Super-PON Spectral Excursion Definition

200.2.9.21

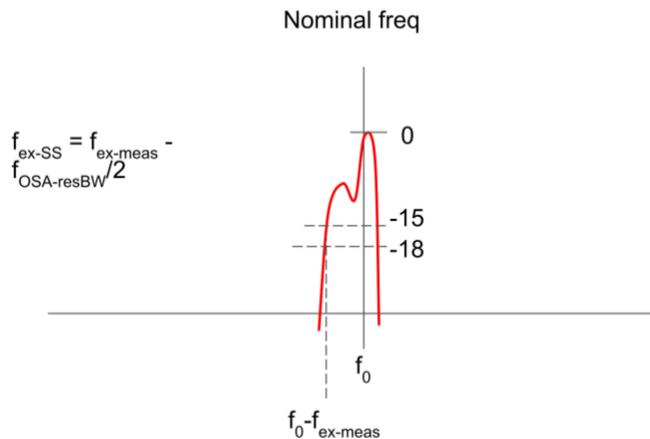
Remove section

Figure 200C-1 – Experimental setup for testing for transient wavelength drift

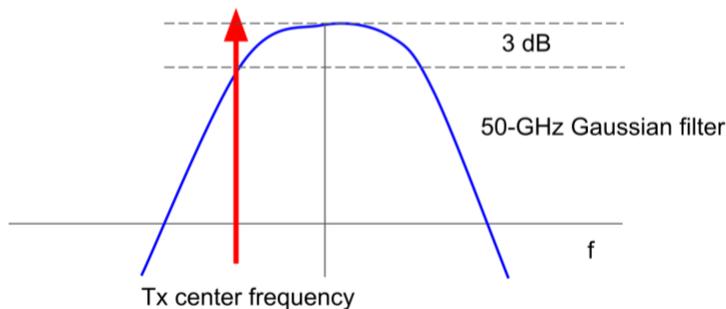
- a) Position a 50 GHz tunable Gaussian optical filter with the center wavelength detuned from the ONU's continuous-mode wavelength by 25 GHz between the transmitter and a linear PIN photodiode, as shown in Figure 200C-1. This results in 3 dB less power into the photodiode relative to ideal alignment between the filter's center frequency to the transmitter;

Figure 200C-2 - A possible power envelop output

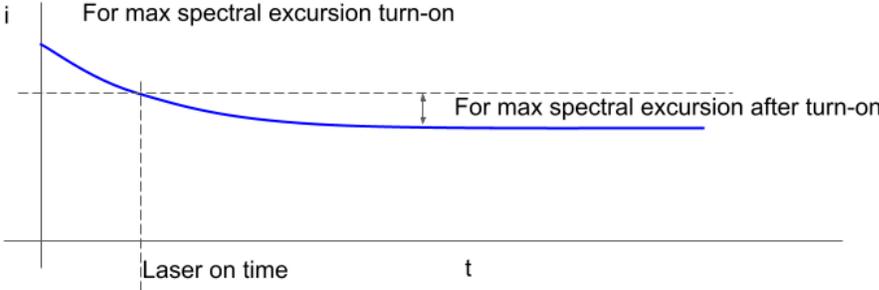
- b) Use a burst-mode signal to drive the ONU transmitter with bursts of >100 us;
- c) Capture the power envelope of the time domain waveform output from the photodiode. The offset optical filter translates frequency shifts into a power envelop change. An example measurement is shown in Figure 200C-2;

- d) Measure the difference in the power envelop between laser on time after the burst start and after the laser has reached steady state; and
- e) Convert the change in the measured power envelop into a transient frequency shift by using the Gaussian relationship of the filter.
